Palmdale Hybrid Power PROJECT

Responses to CEC Data Request Set 1 (1-88)

Docket 08-AFC-9

PALMDALE HYBRID POWER PROJECT (08-AFC-09)

Habitat Communities
Figure 6-S

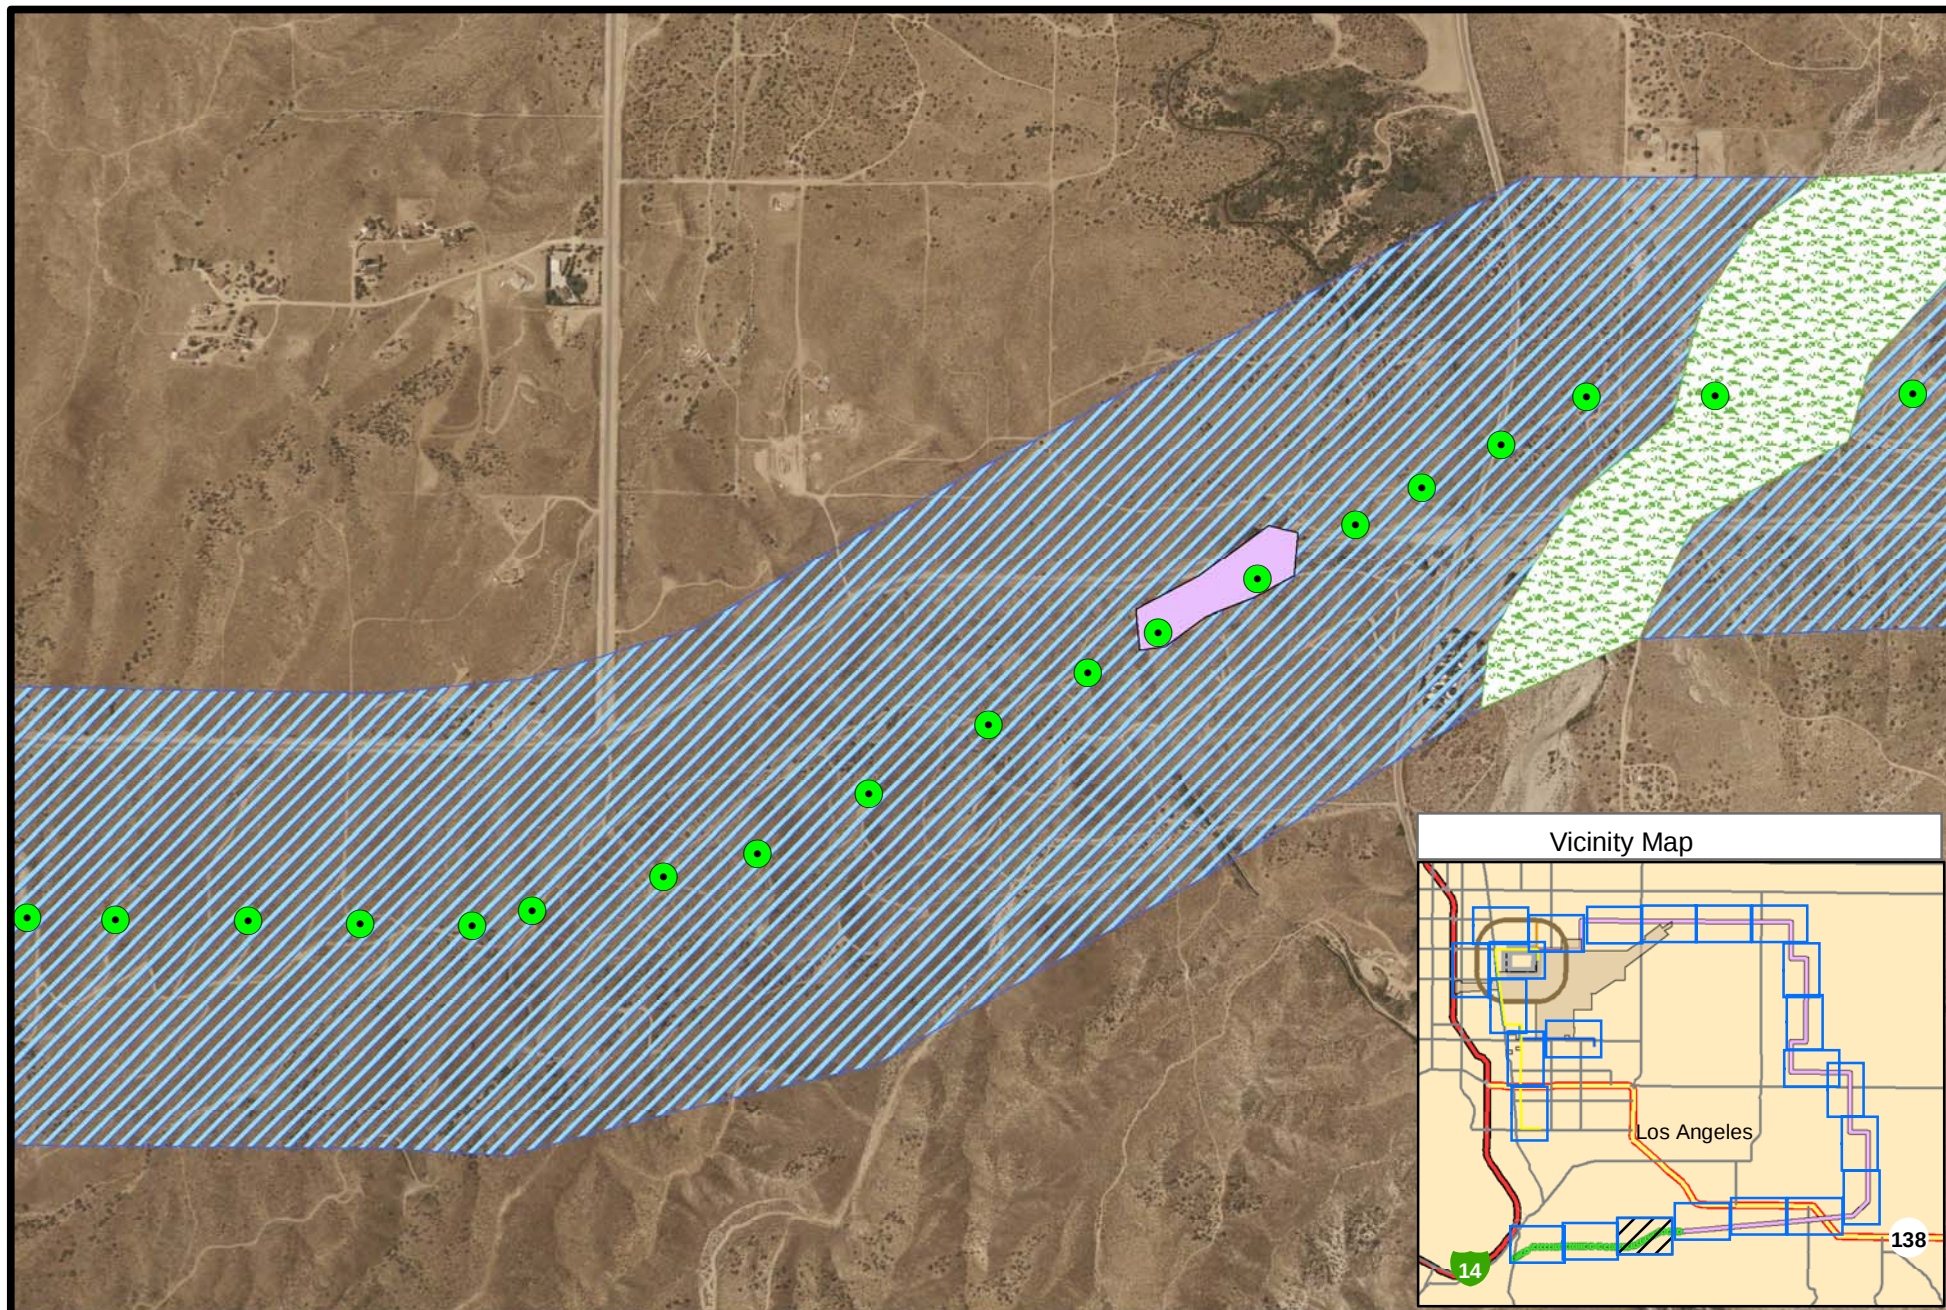
Please provide an updated map or aerial photograph for Figure 6 at a suitable scale that identifies the location of the Southern Riparian Scrub plant community.

Please see the attached revised Figure 6-S (Rev.1). Southern Riparian Scrub is an early successional community of Mojave Riparian Forest. Both are present in the location illustrated in Figure 6-S (Rev.1). This revised figure is provided at the end of this section.

**1941 ELIZABETH LAKE 1:125,000 SCALE TOPOGRAPHIC
MAP**

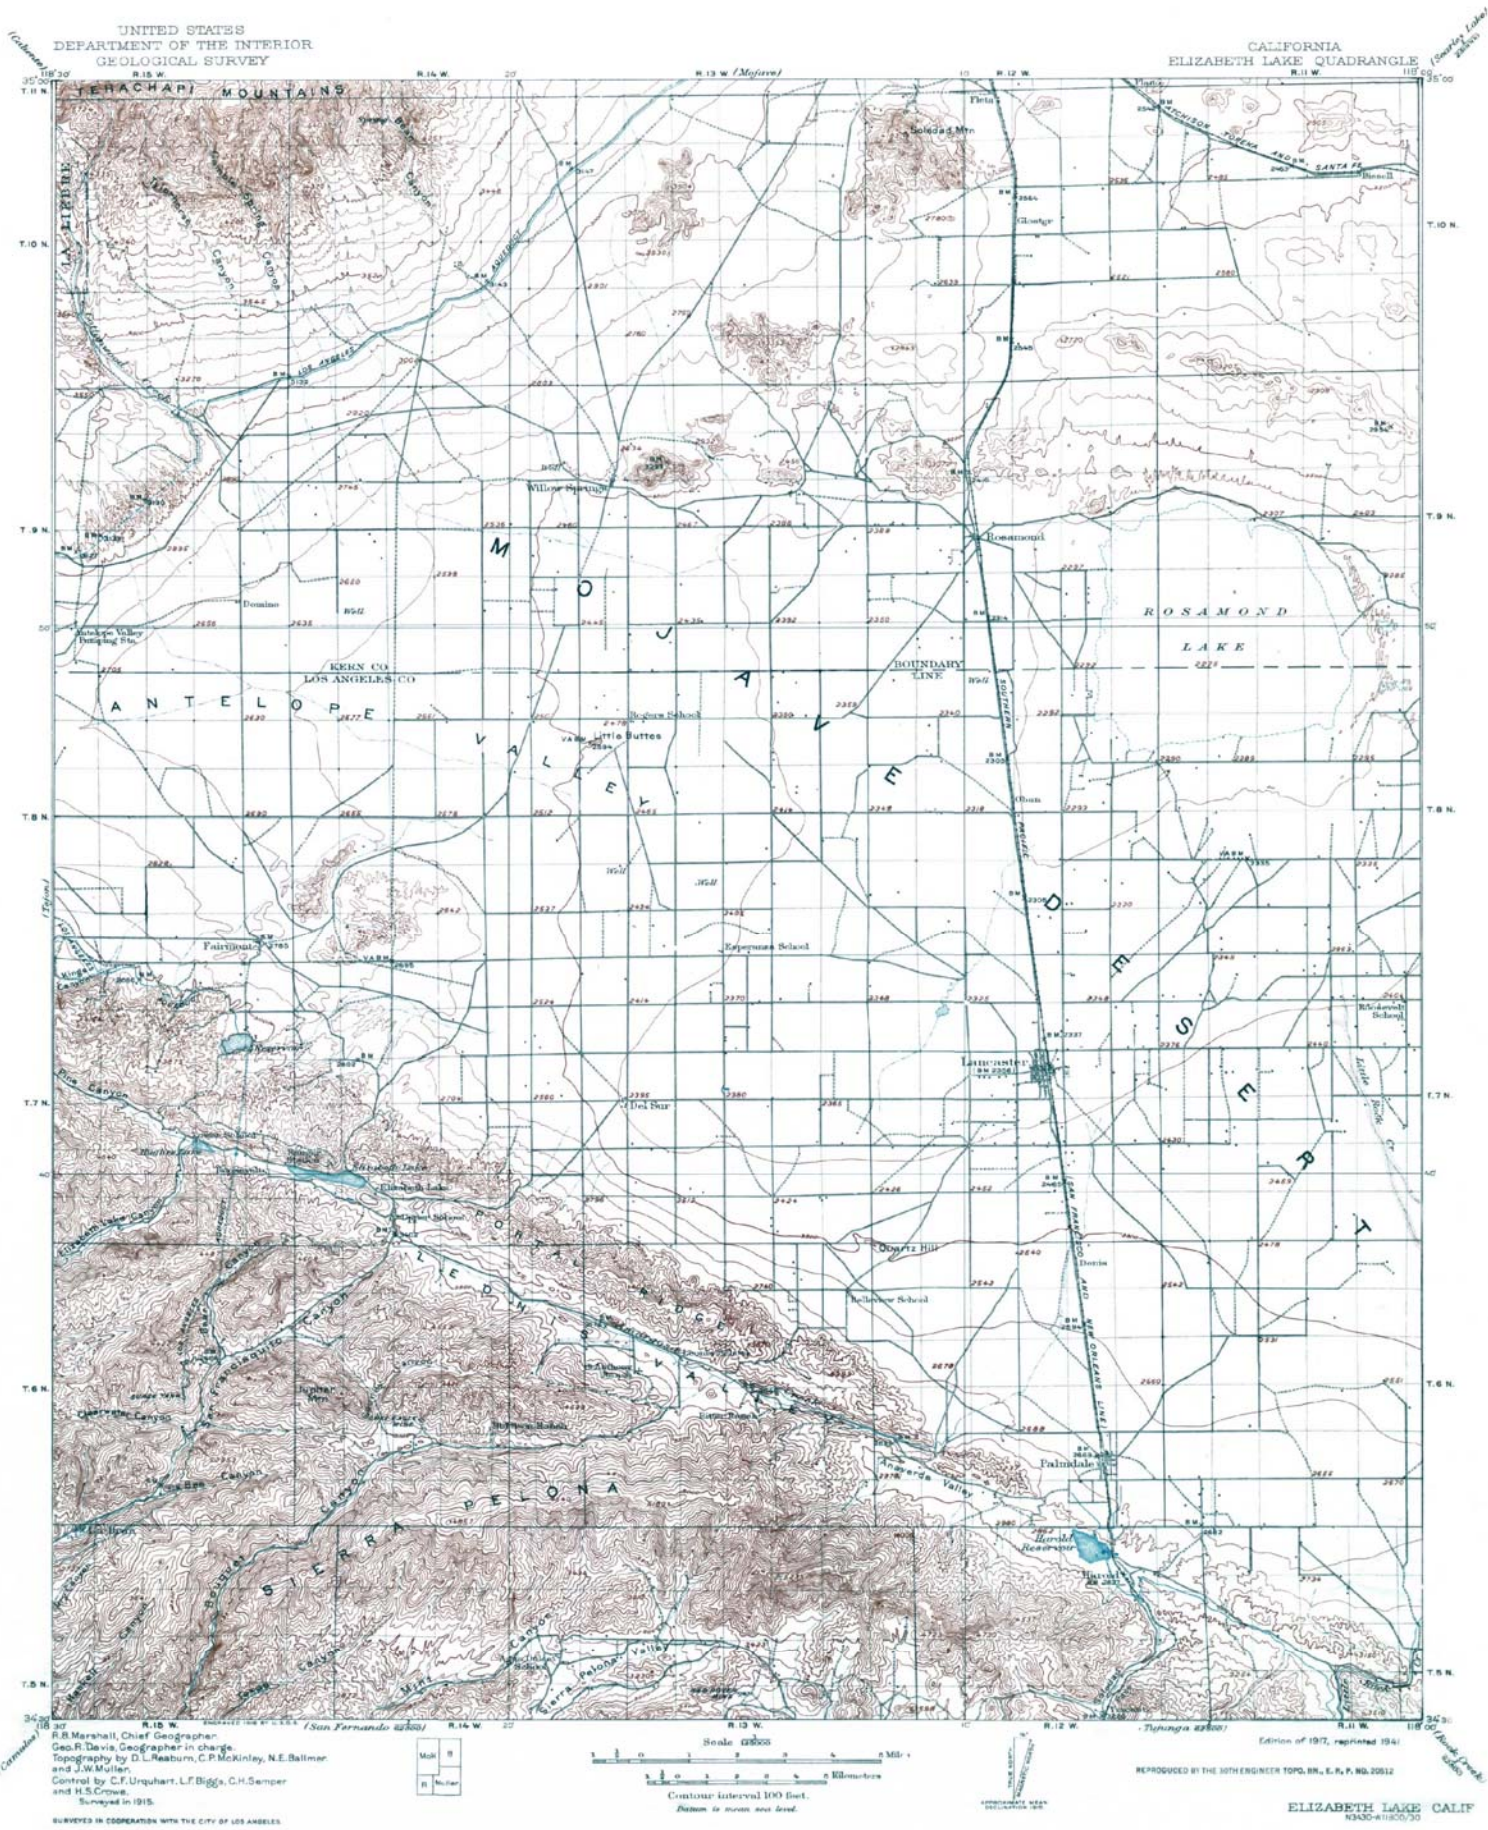
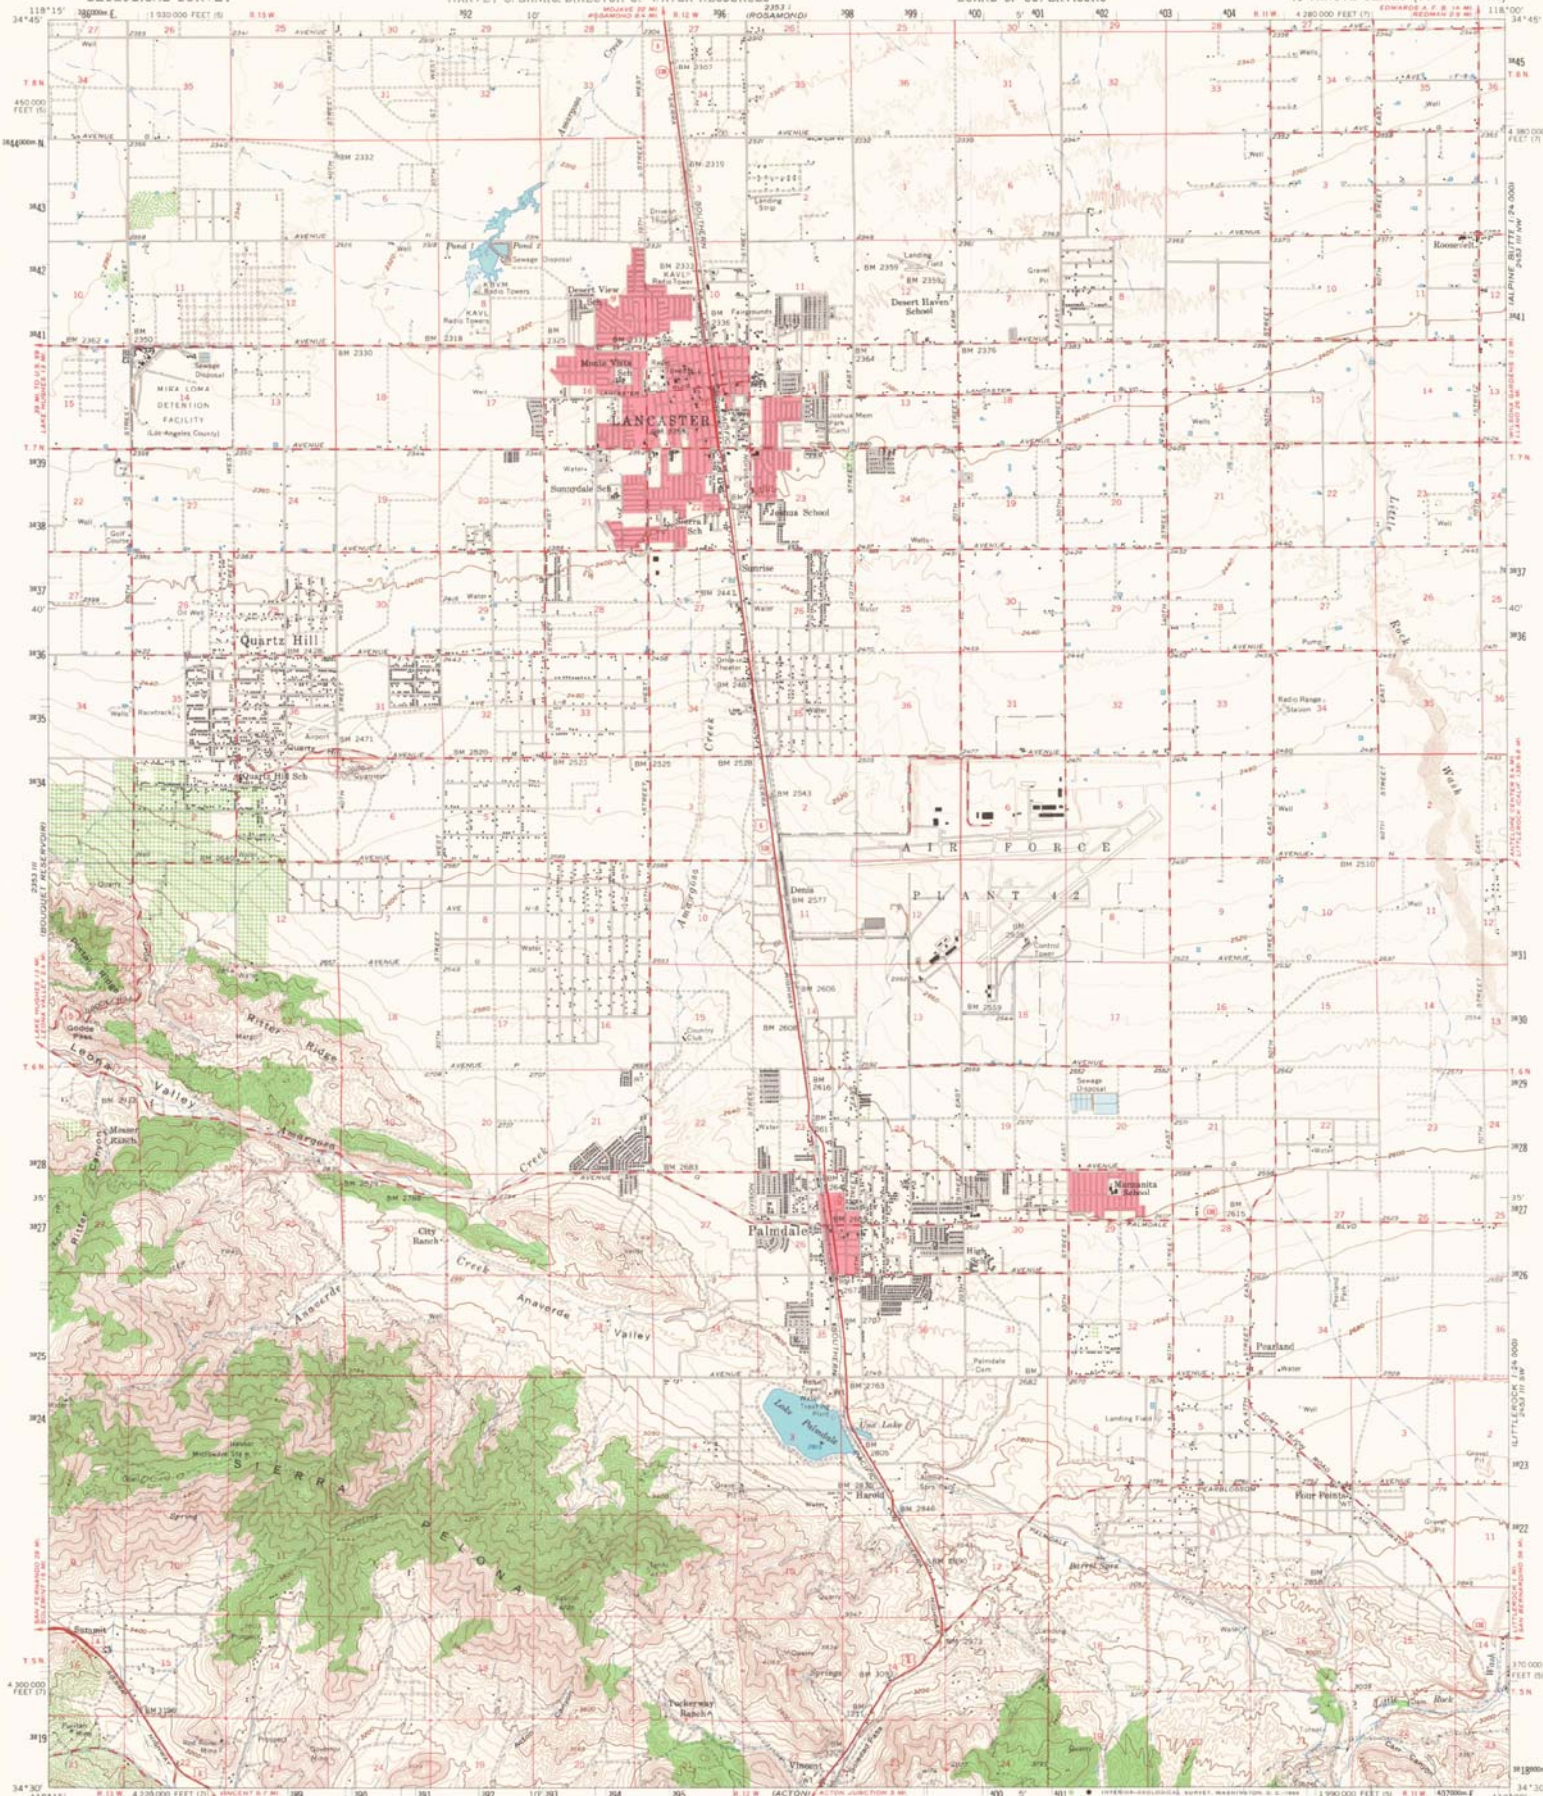
Please provide color copies of all available historic US Geological Survey (USGS) topographic maps that cover the entire project area. Copies reduced in size are acceptable, as long as printed information on the maps is legible.
